**CHABOT-LAS POSITAS  
COMMUNITY COLLEGE DISTRICT  
PURCHASING DEPARTMENT**

**Addendum No. 4  
INVITATION TO BID No.: B20/21-08  
Agriculture Science, Horticulture Facility Project**

CLPCCD - LAS POSITAS COLLEGE  
**AGRICULTURE SCIENCE HORTICULTURE FACILITY**  
3000 CAMPUS HILL DRIVE,  
LIVERMORE, CA 94551

**IDF ROOM 107A ENLARGED PLANS AND ELEVATIONS**

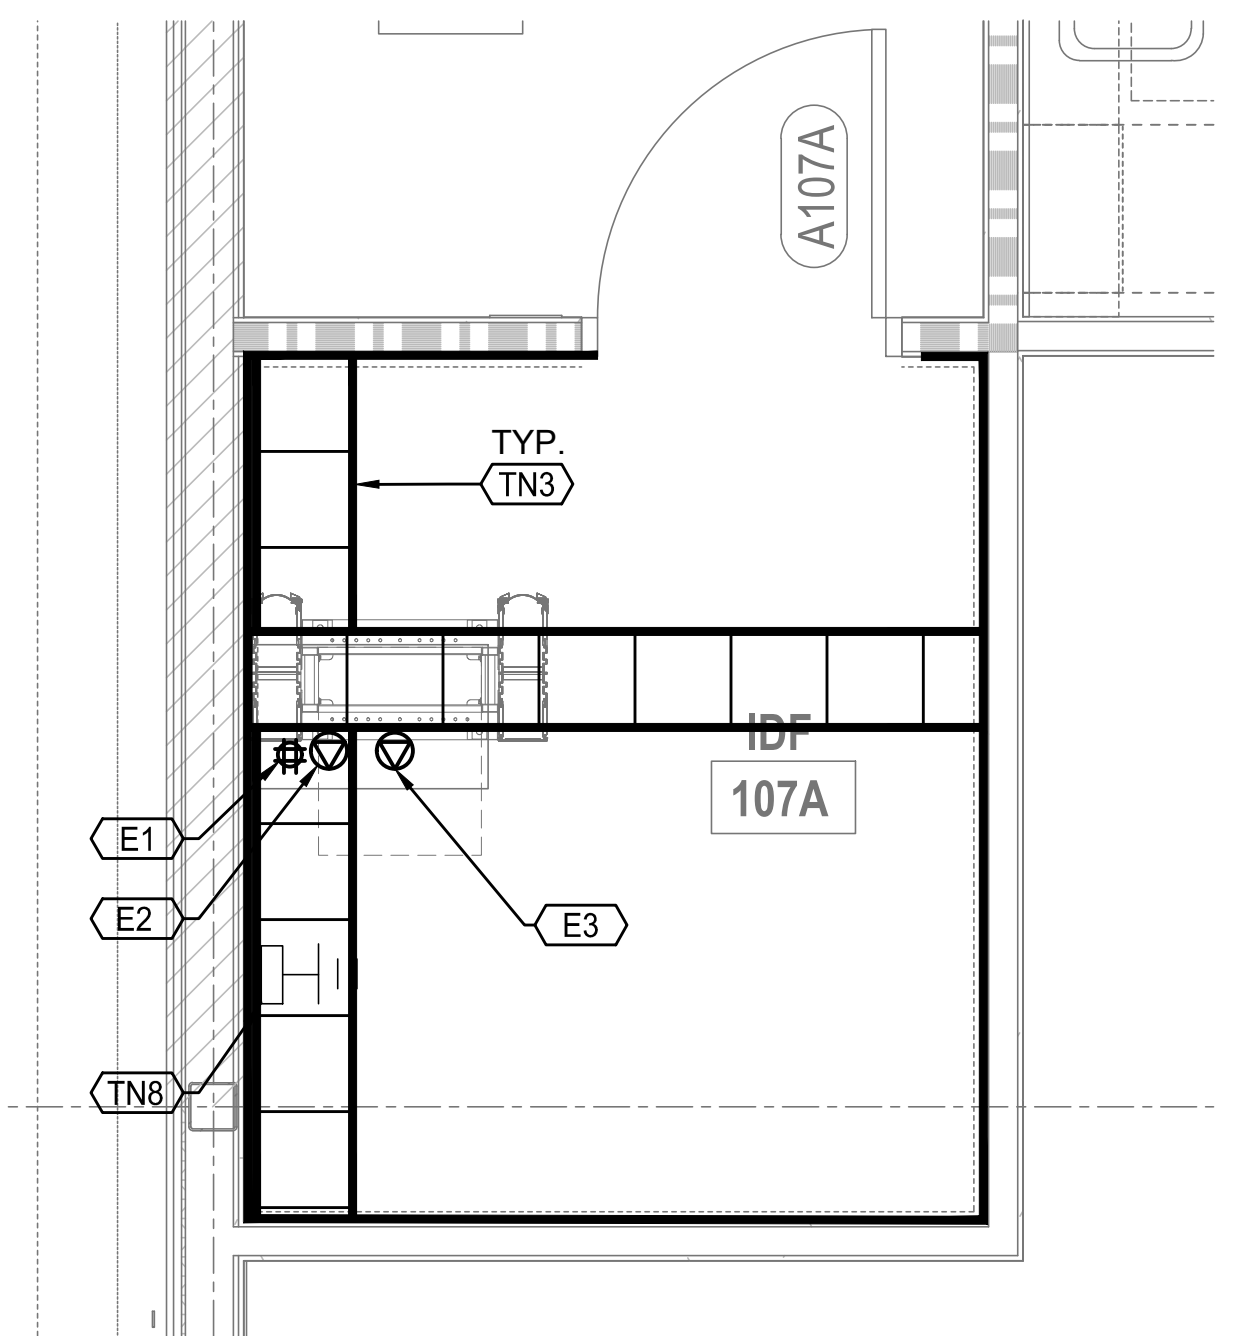
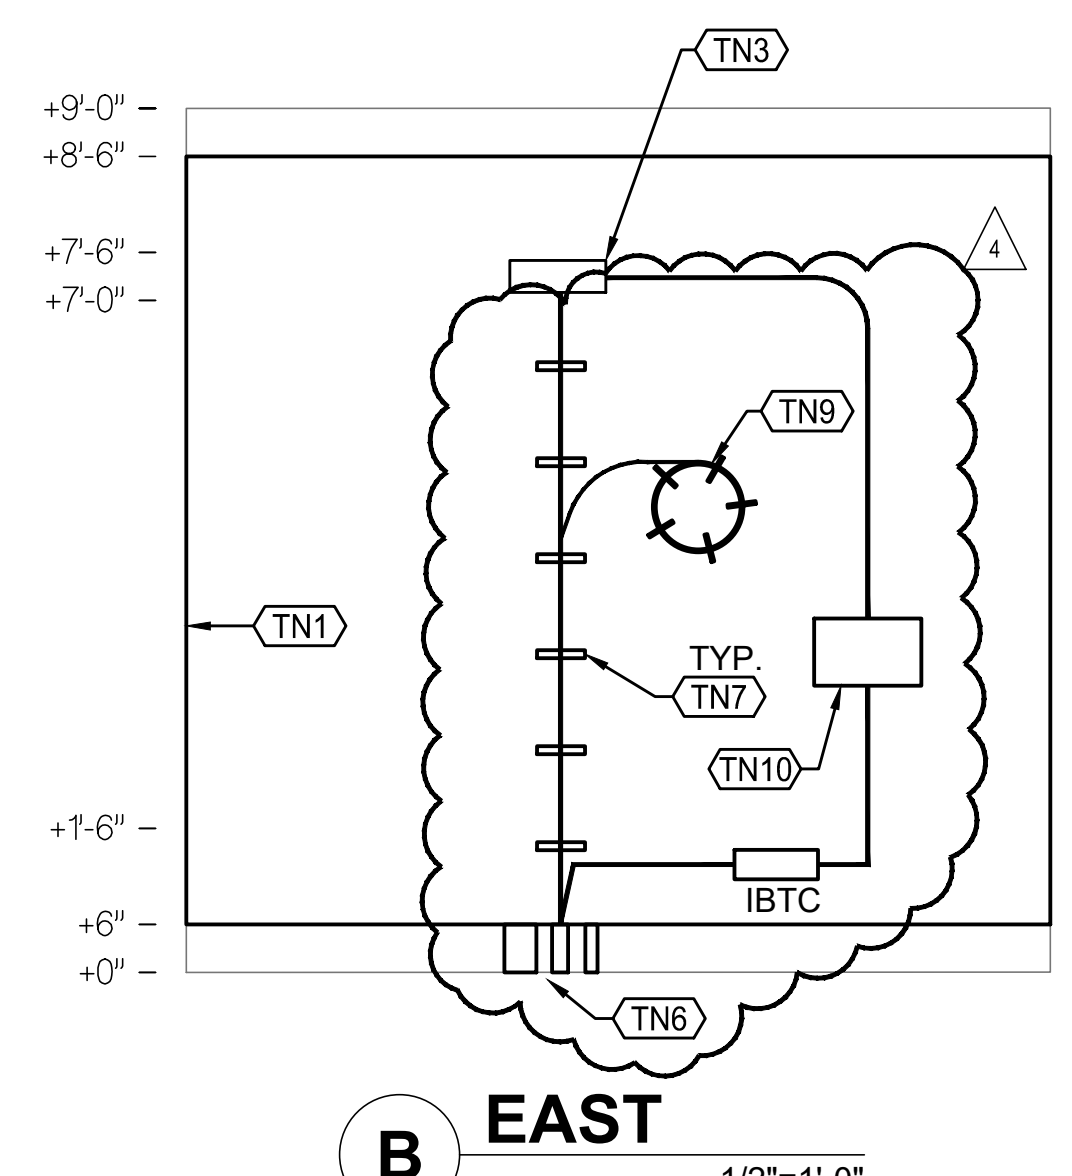
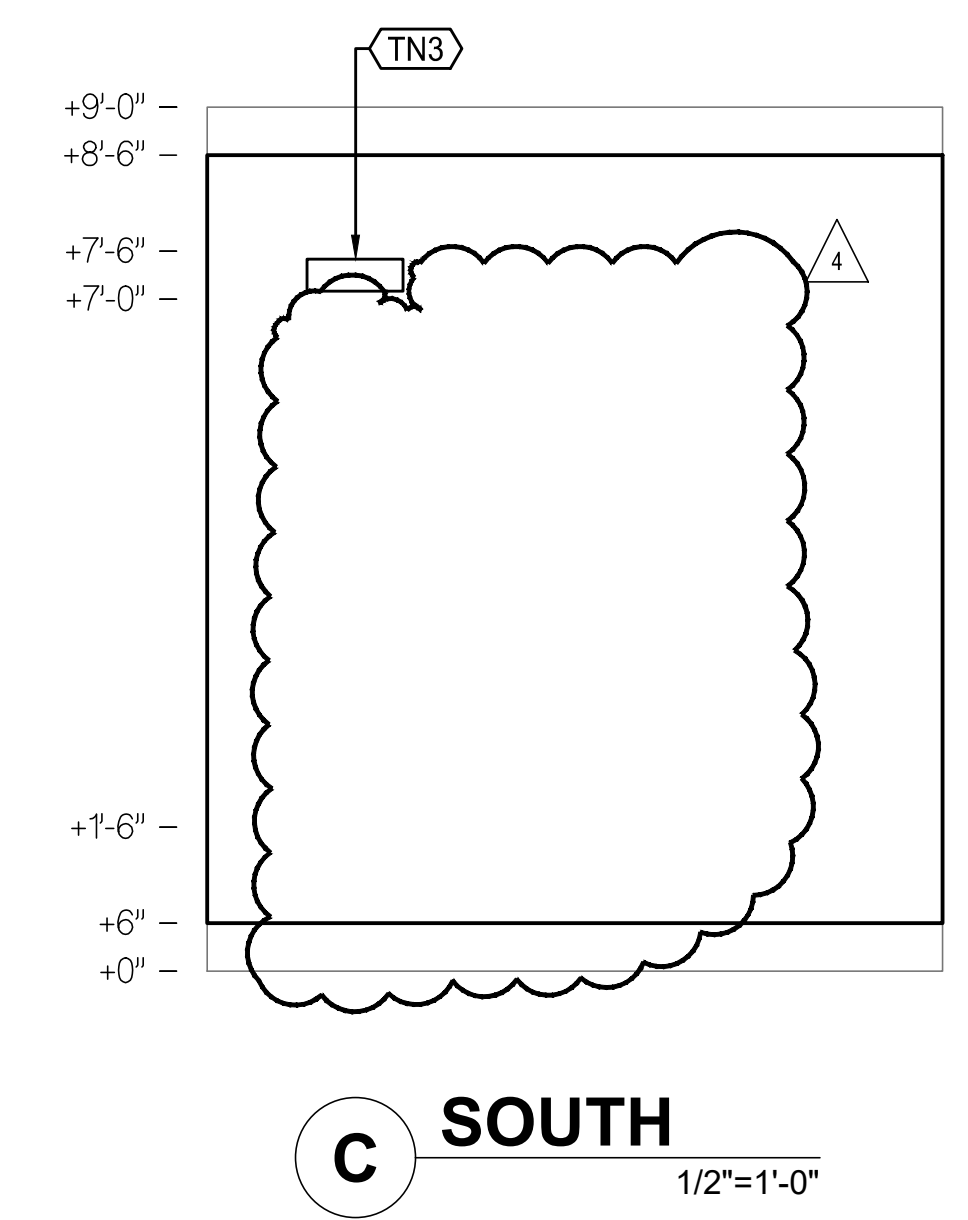
13. **Sheet TA101 – Telecom Site Plan:**
    - a. Updated conduit route.
    - b. Revised Keynote TN1.
    - c. Added Keynotes TN5, TN6 and TN 7.
  14. **Sheet TA401 – IDF Room 107A Enlarged Plans and Elevations:**
-

- a. Updated Keynote TN6.
  - b. Revised conduit location on IDF Room 107A, Enlarged Plan 1.
  - c. Revised conduit route on Elevations B and C.
- 15. Sheet TN802 – Telecom Site Plan:** Added Keynote TN8.
